15. (Amended) A TFT LCD having a first substrate, a second substrate, and liquid crystal sealed between the first and second substrates, comprising:

REMARKS

At the outset, the Examiner is thanked for the thorough review and consideration of the subject application. The Office Action of February 19, 2002 has been received and contents carefully reviewed.

FIG. 2B

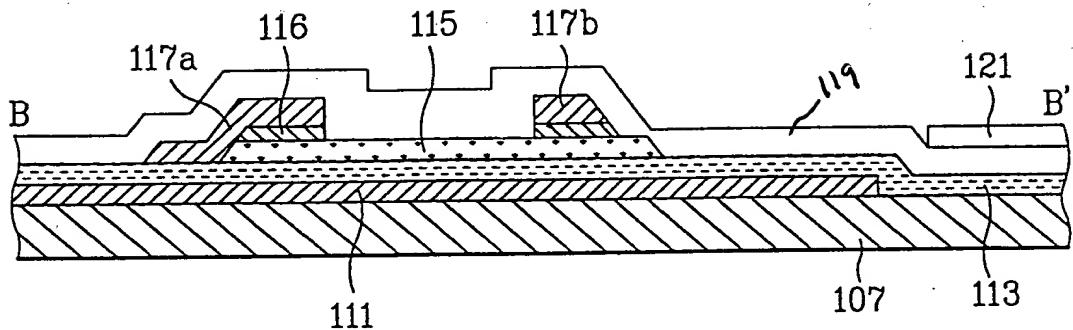
The Examiner objected to the disclosure because of informalities on page 5, lines 17 and 23, and in Figure 2B. Applicant has amended the specification and the drawings to correct the informalities noted by the Examiner and other informalities in the translation. No new matter has been added.

approved
Loke
8/6/02
